### **URGENT FIELD SAFETY NOTICE**

Product Name: **Alaris™ / Asena™ GS, GH, CC, TIVA, PK, Enteral Syringe Pump**  
Product codes with prefix (all variants): **8001, 8002, 8003, 8004, 8005, 8007**  
FSCA Identifier: **RA-2018-03-01**  
Date: **May 2018**  
Type of Action: **Field Safety Notice**

**Figure 1:** Backplate and S5 spring location on an Alaris syringe pump.

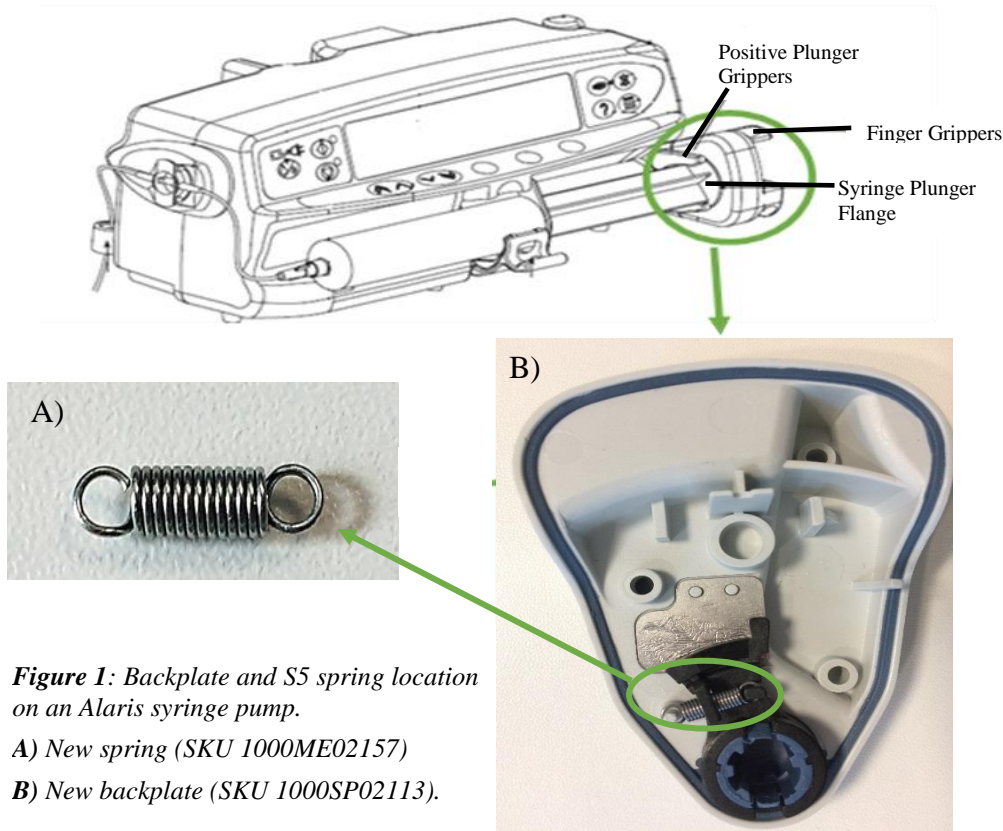
BD is undertaking a corrective action on its Alaris™ / Asena™ syringe pumps to replace the existing gripper plate actuating spring (S5) design with a new improved design, which is located on the back-plate of the syringe plunger holder as shown in Figure 1 A) and B). This is being undertaken to improve performance and reliability of the S5 spring to reduce the risk of harm to patients. This corrective action supersedes the Alaris™/ Asena™ syringe pump S5 spring replacement, FSN RA-2017-02-02, issued in March 2017.

BD has identified that the gripper plate actuating spring (S5), can break and may prevent the gripper fingers from securing the syringe plunger within the plunger holder mechanism which causes a small gap between the syringe plunger flange and the syringe drive mechanism. See Figure 1.

**A)** New spring (SKU 1000ME02157)

**B)** New backplate (SKU 1000SP02113).
